PL202400104
PL2024-104

PENN AVE TOWNHOMES

SITE PLAN

C2.0

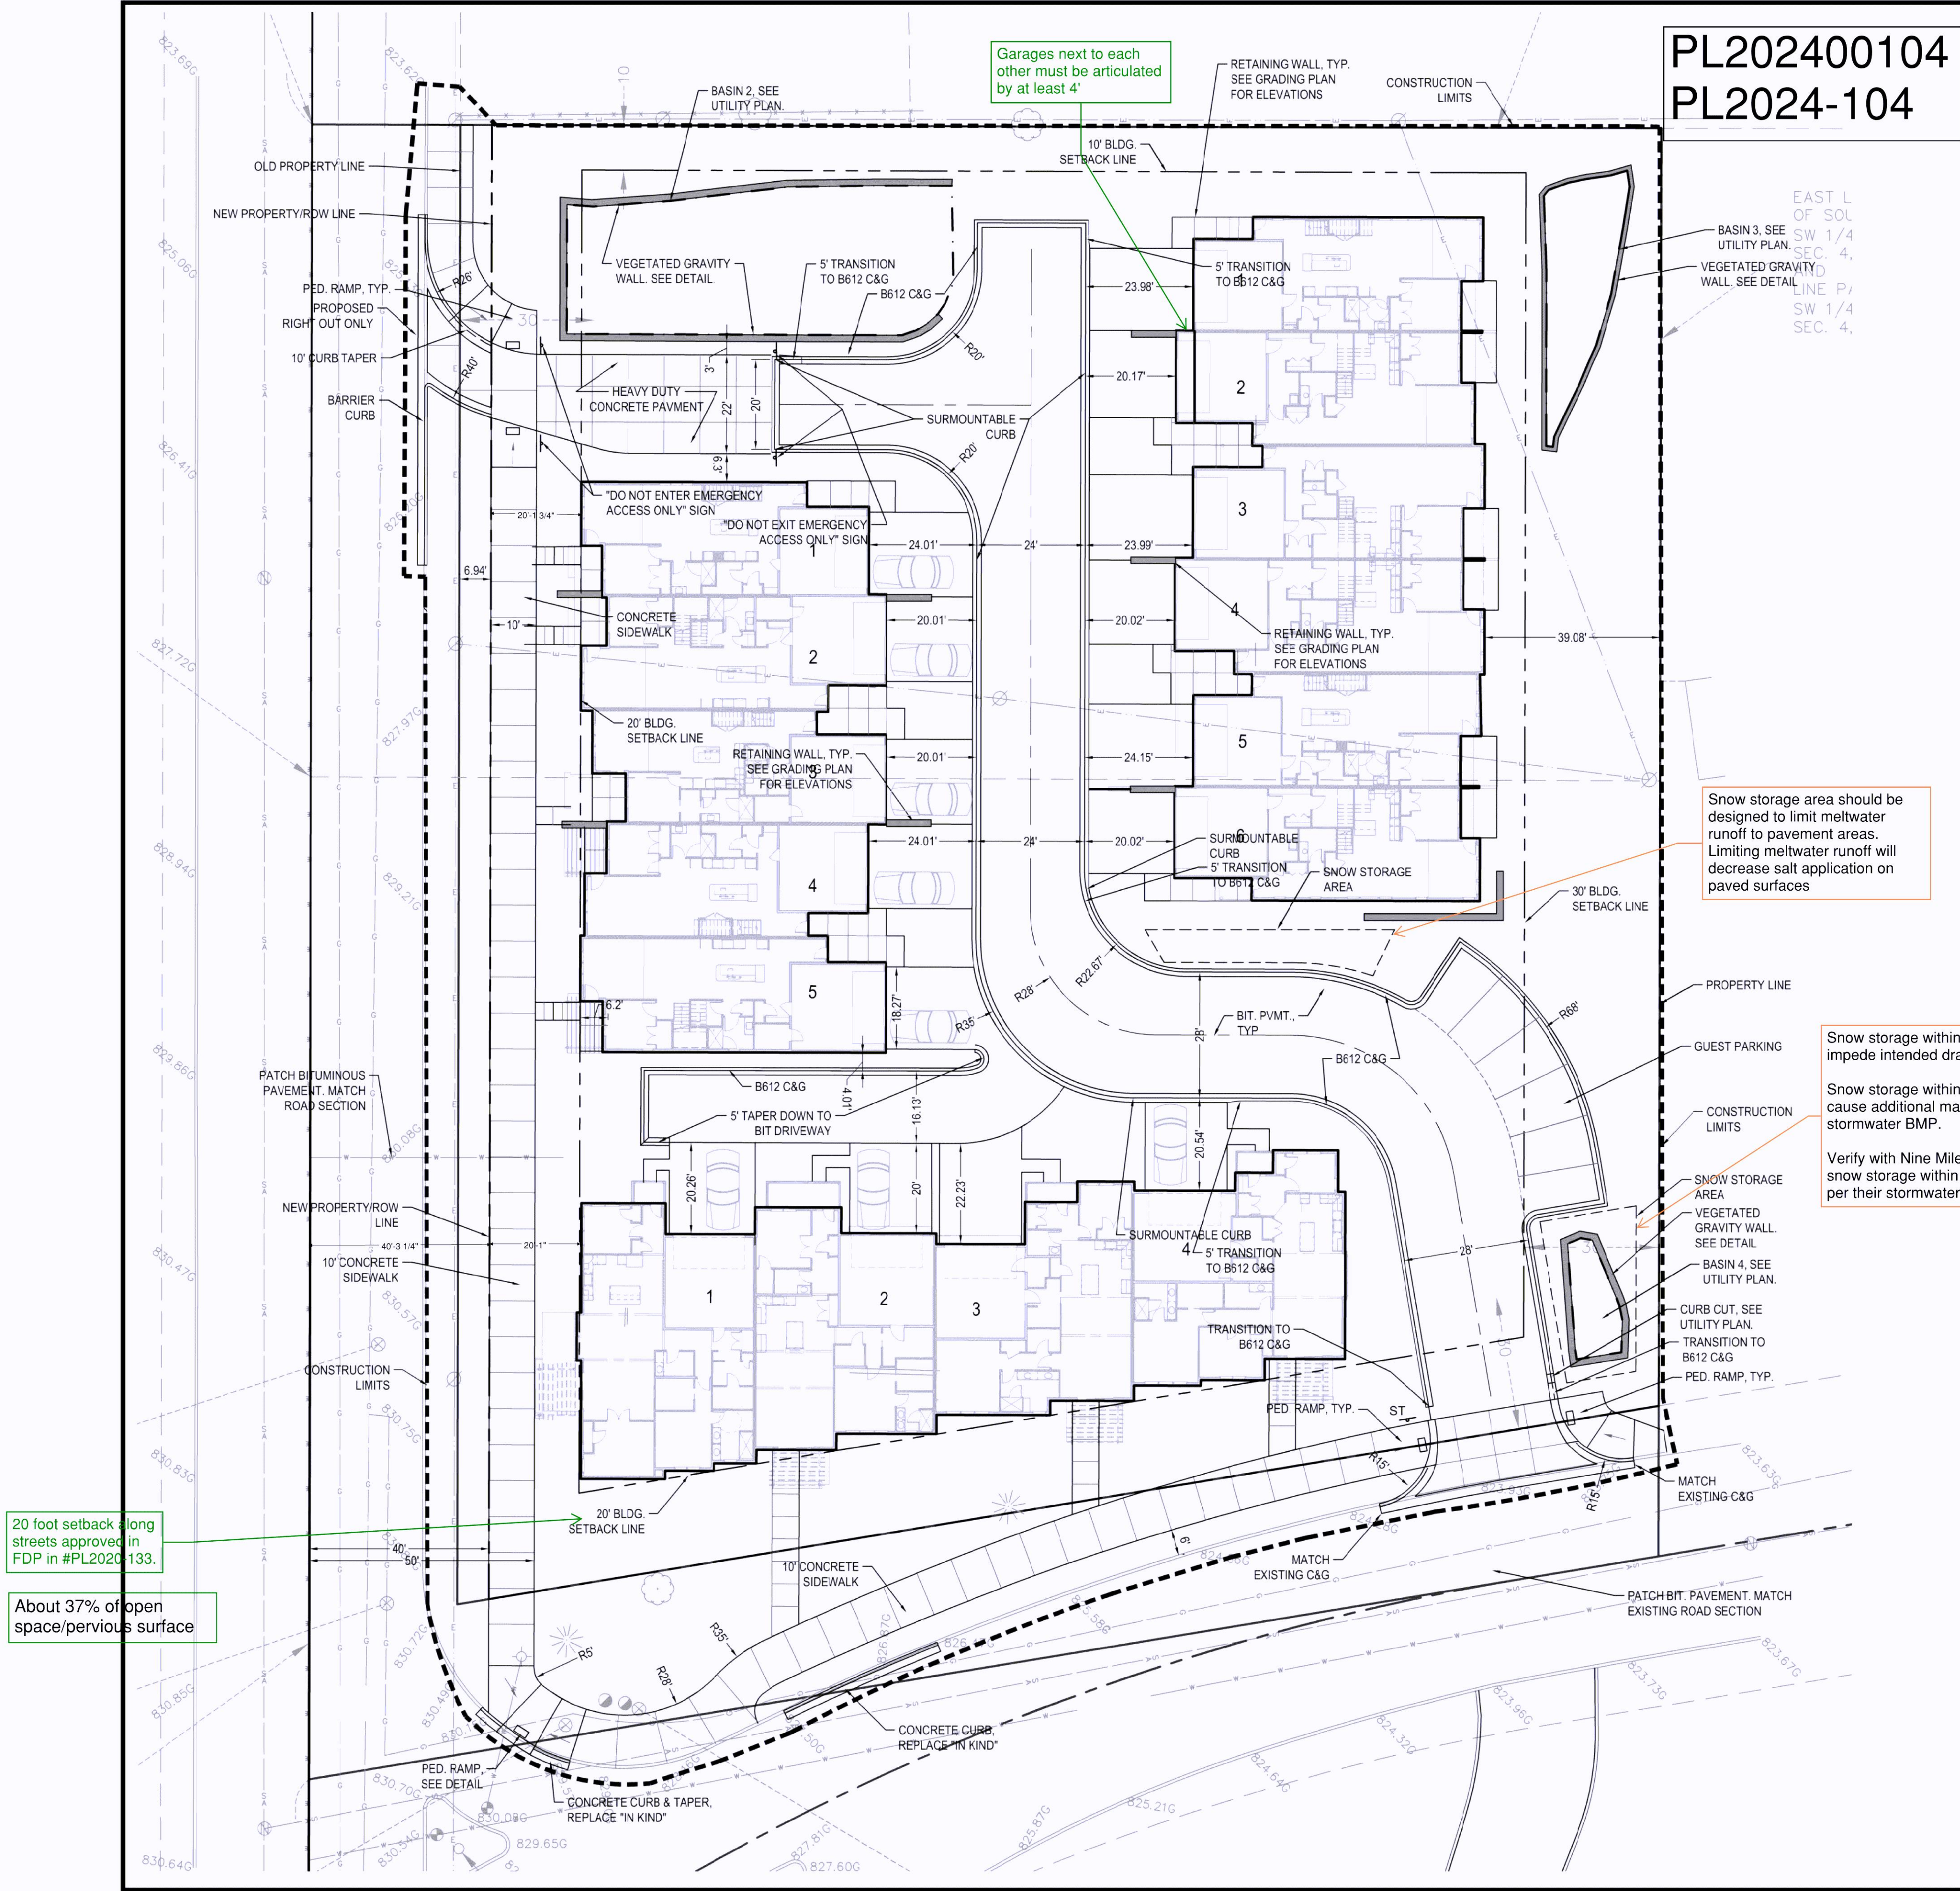
20 foot setback along streets approved in FDP in #PL2020-133.

About 37% of open space/pervious surface

Show lot lines and easement lines.

Based on the current plan, all units would be required to be sprinklered.

Hydrant coverage shall be provided within 150' of all portions of the structures.

Provide adequate turning radius for all emergency vehicle access lanes to accommodate Ladder 3

A looped water supply feeding a single, combined water service is required for the domestic and sprinkler system water demand.

Building/property shall be adequately signed for emergency response.
